MEMORANDUM

From:	Tina Cuss Ecology Officer		
Service	WBC Ecology	App No:	250702
Address:	19 Grovelands Road, Spencers Wood, Wokingham, RG7 1DP.		
Proposal:	Full application for the proposed erection of new church building (Use Class F1), construction of front wall and gates along with associated landscaping and car parking following demolition of existing buildings.		
Type of Development:	Minor All other developments		
Site Visit Made:	No

Figure 2. Building layout

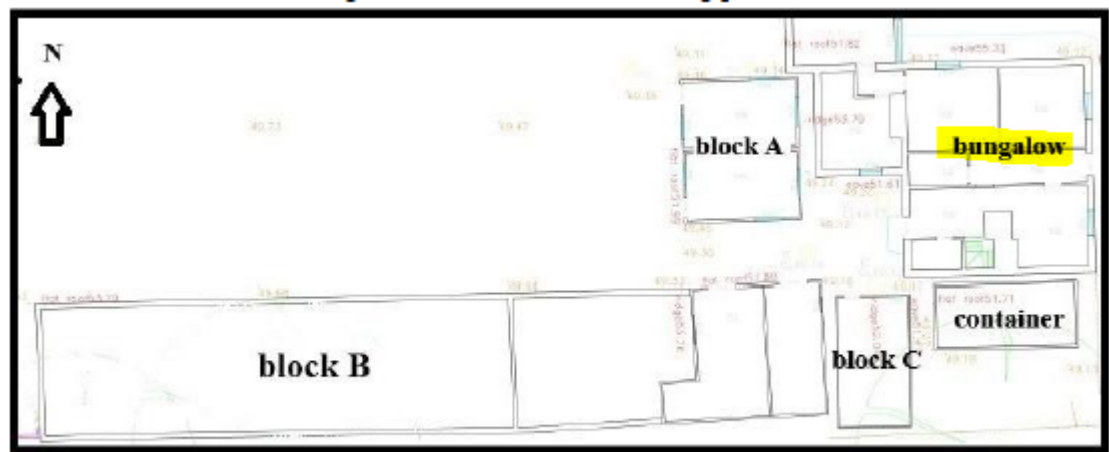
The PRA inspection surveys of the outbuildings at 19 Grovelands Lane fails to include any internal or external inspection of the brick-built bungalow with wooden barge boards and soffits and clay tile roof. The building has numerous potential roosting features for bats and is located in an area where bats have been recorded in similar properties. The search of MAGIC bat mitigation licence records did not include a comprehensive desk top search of planning history or bat group or TVERC species records. The Ecologist has therefore failed to consider records of roosts in the immediate vicinity including at 20 and 14 Grovelands Road.

The application must not be favourably determined until a bat survey of the building

proposed to be demolished has been considered by the LPA and mitigation measures can be secured. I am happy to provide comments when a revised Preliminary Roost Assessment and any subsequent surveys recommended by the Ecologist have been submitted.

Awaiting a PRA of the bungalow building and bat mitigation strategy.
